SUPPLIER DISPOSITION REQUEST (SDR)

2. SDR No. 02

5. Purchase Order No. 5A-05150

6.1 L143-00031 Date 4.4.05 04

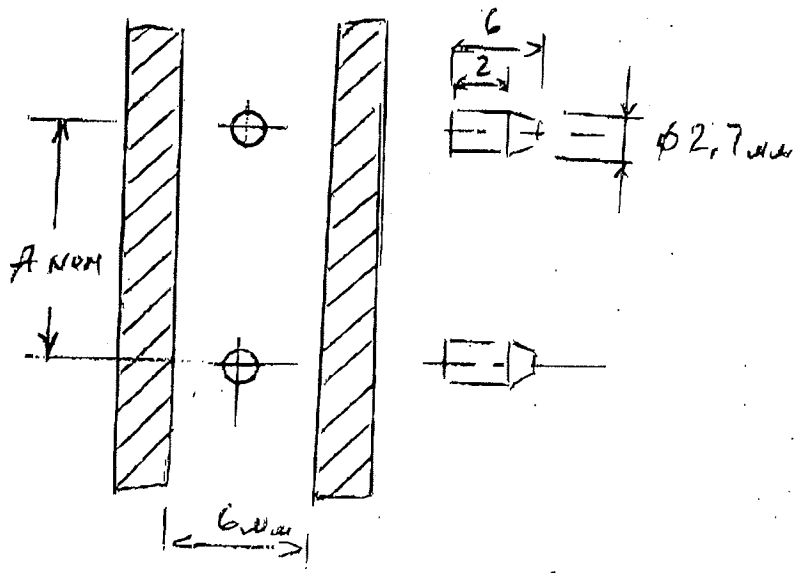
Hi-TECH manufacturing is asking permission to controle position of the threaded holes #6-32-UNC. 3.5mm ±.05 at the pole Base using special „Go" fixture (Sketch attached).

We are positive, that location of the threaded holes is correct, because it is supported by the absolutely uniform manufacturing procedure. That's why we ask permission to record hole location in each tenth pole.

17. ANL Disposition and Remarks: Accept inspection procedure
